Access Compliance Report Public Rights-of-Way (RR Crossings)

Intersection ID: 10025341	Main Street: E_7TH_ST	Location: N/A
ADA ID: 7B871F7258DE	Overall Compliance: No	Severity Score: 0.0
Codes/Mitigation Info/Possible Solution		Field Measurements/Component Compliance

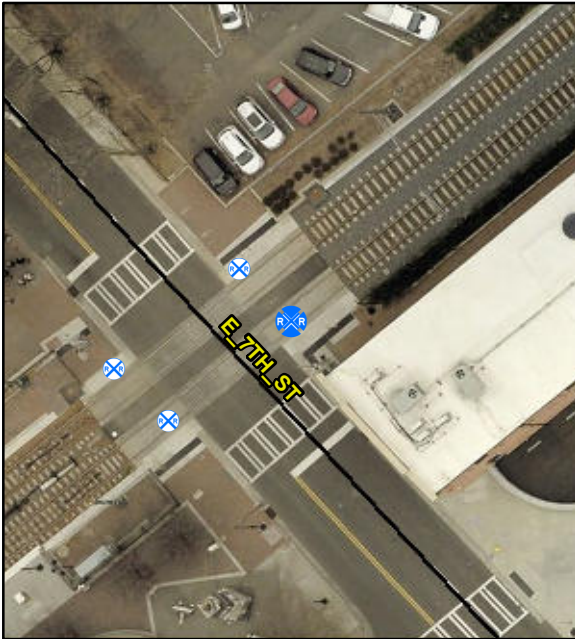
R302.7.4, R305.2.5

Compliance	Description	Data
Yes	DWS Provided?	Yes
Yes	DWS Contrast?	Yes
Yes	DWS Width (in)	Yes
Yes	DWS Length (in)	24.0
No	DWS Offset (in)	70.0
No	Pedestrian Gate?	No
N/A	DWS Outside Gate?	Yes
N/A	Rail Type?	LightRail
No	Flangeway Gap (in)	2.75
Yes	Sidewalk Width (in)	202.0

**Remove & Replace Detectable
Warning System. Provide Pedestrian
Gate. Remove & Replace Walking
Surface Adjacent to Rail.**
